Access Compliance Report

Public Rights-of-Way

(Curb Ramps)

Intersection ID: 23744	Main Street: ALEXANDER_RD	Cross Street: PINEVILLE-MATTHEWS_RD	Location: SE
ADA ID: 3679BE6E06B6	Ramp Type: PerpDiag	Initial Pass/Fail: Fail	Overall Compliance: No
Severity Score: 21.25			
Codes/Mitigation Info/Possible Solution		Field Measurements/Component Compliance

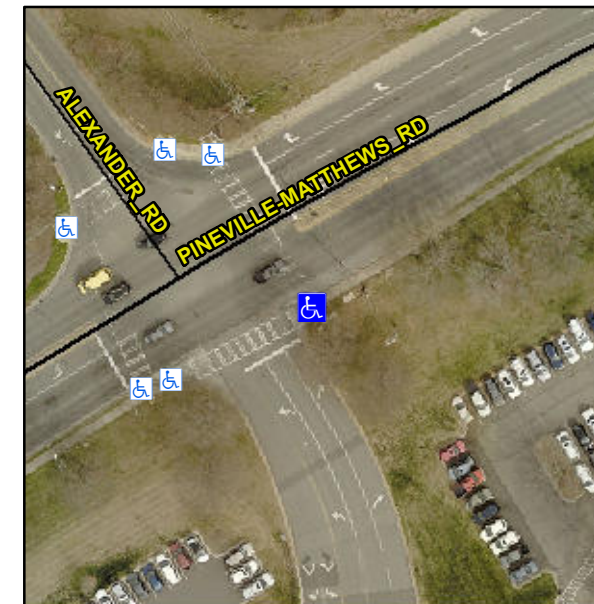
Not Found, R304.5.1, R304.2.2

Compliance	Description	Data	Compliance	Description	Data
N/A	Ramp Length (in)	49.0	No	Ramp Slope (%)	10.2
No	Ramp Width (in)	43.0	Yes	Ramp XSlope (%)	0.7
N/A	Flare Type LT	N/A	N/A	Flare Type RT	N/A
N/A	Flare Slope LT (%)	N/A	N/A	Flare Slope RT (%)	N/A
N/A	Flare Traversable LT?	N/A	N/A	Flare Traversable RT?	N/A
N/A	Landing Length (in)	N/A	N/A	DWS Provided?	N/A
N/A	Landing Width (in)	N/A	N/A	DWS Contrast?	N/A
N/A	Landing Slope (%)	N/A	N/A	DWS Length (in)	N/A
N/A	Landing X Slope (%)	N/A	N/A	DWS Full Width?	N/A
N/A	Landing Curb? (Y/N)	N/A	N/A	DWS Offset (in)	N/A
N/A	Shared Landing?	N/A			
N/A	Gutter Ponding?	N/A	N/A	Gutter Slope (%)	N/A
N/A	Gutter Lip Ht (in)	N/A	N/A	Gutter X Slope (%)	N/A
N/A	Painted X Walk1?	No	N/A	Painted X Walk2?	No
	X Walk 1 Direction	To N		X Walk 2 Direction	To W
N/A	X Walk 1 Width (in)	N/A	N/A	X Walk 2 Width (in)	N/A
	X Walk 1 Slope (%)	3.6		X Walk 2 Slope (%)	0.6
	X Walk 1 X Slope (%)	1.4		X Walk 2 X Slope (%)	0.6

Remove & Replace Curb Ramp With Two New Directional Ramps or Equivalent.
